N1077A-01

# Information Only Service Note

## N1077A 32 GBd Optical/Electrical Clock Recovery

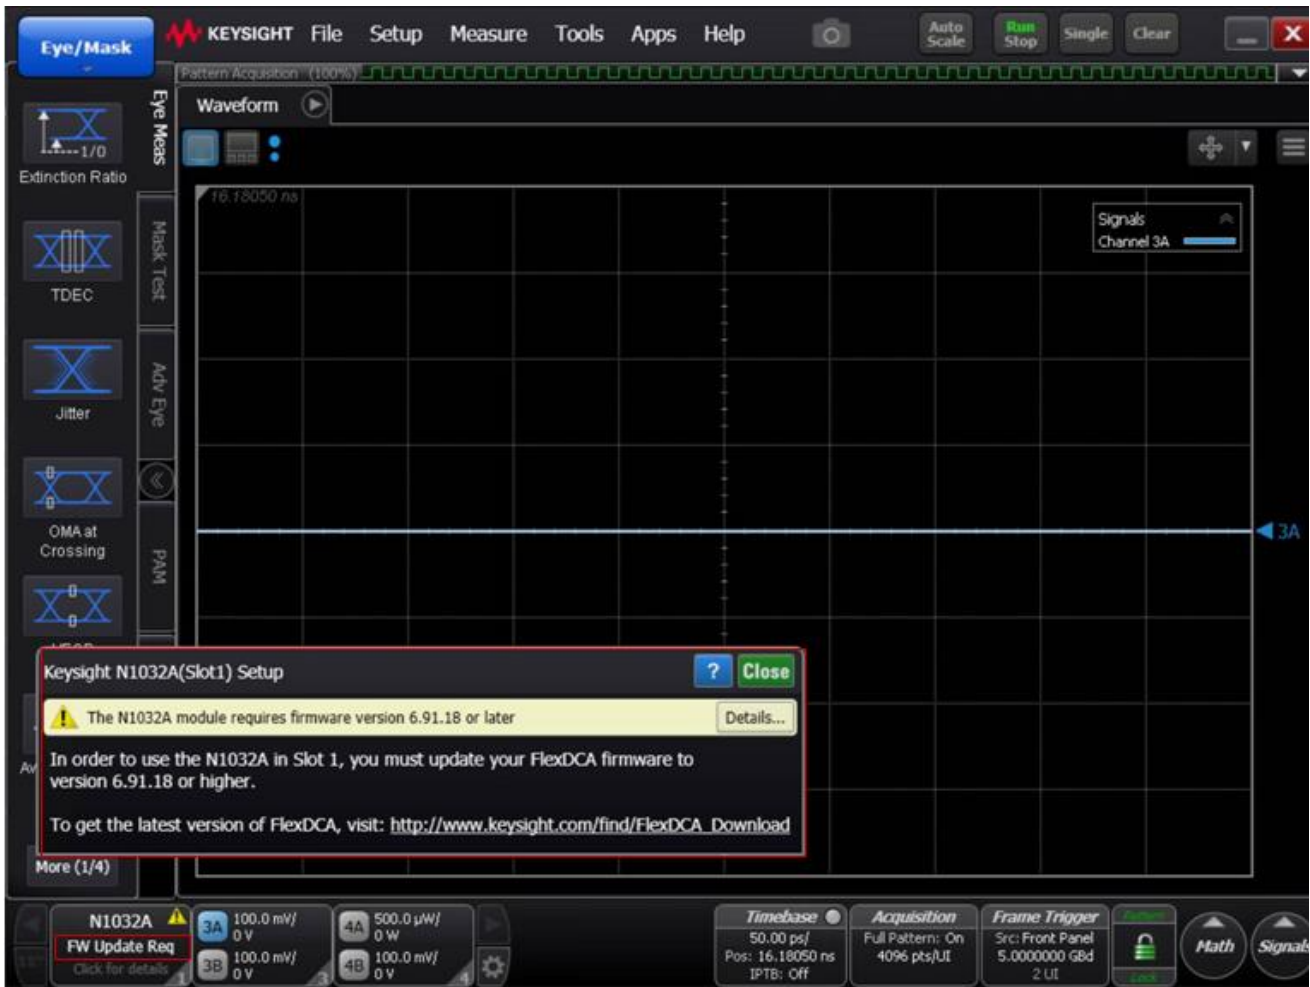
With the instrument connected to FlexDCA, if a message like the one below is displayed, FlexDCA must be updated to the indicated version (or later):

To update FlexDCA software, download from [www.keysight.com/find/flexdca\\_download](http://www.keysight.com/find/flexdca_download) and install. While only the indicated version is required, updating to the latest version is recommended.
